Atmos. Meas. Tech. Discuss., 3, C1760–C1770, 2010

Interactive comment on “Ceilometer-lidar inter-comparison: backscatter coefficient retrieval and signal-to-noise ratio determination” by B. Heese et al.

Received and published: 19 October 2010

Fig. 1. is Fig. 2 of the original paper: Daytime particle backscatter coefficient profiles derived from the CHM ceilometer data from DWD in Holzhausen (in red) and lidar data (in blue). ...

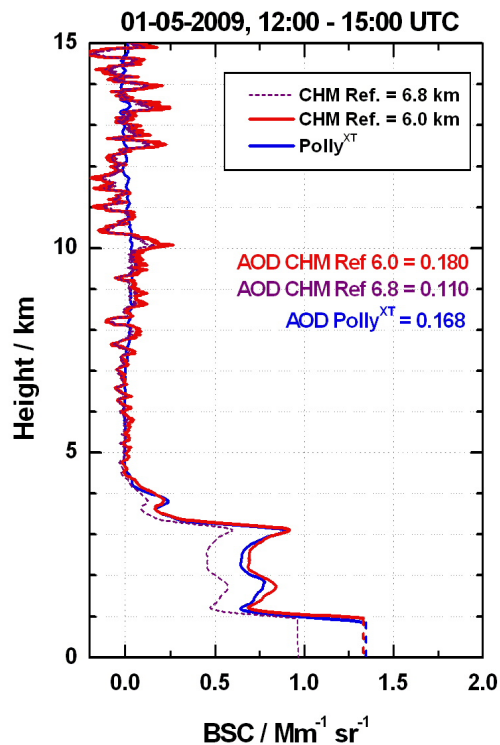
Page 3914, line 9-11: I don't understand the numbers given (0.18/0.17/0.15); they are in contradiction to Fig.2. And I don't come up with errors of 11/12%, if I use the given numbers.

Answer: Yes, the numbers in the plot were indeed from another case and were mixed in here by accident. To be on the safe side, I calculated all profiles and resulting AODs again and came up with the numbers in the text.

modified text and new Figure 2:

On 1 May 2009 the AOD derived from the ceilometer profile is 0.180 and the one from the lidar profile was calculated to 0.168. The independent measurement of the AOD by IfTs sun photometer interpolated to 1064 nm over the same time period yields a value of 0.140. These are differences in the order of 20%, which may be explained by the distance between the measurement sites as well as to the extrapolation of the

extinction profile to the ground with a constant value. Differences in this range were to be expected considering the different measurement sites. However, the shape of the particle backscatter profiles from both instruments compare quite well.
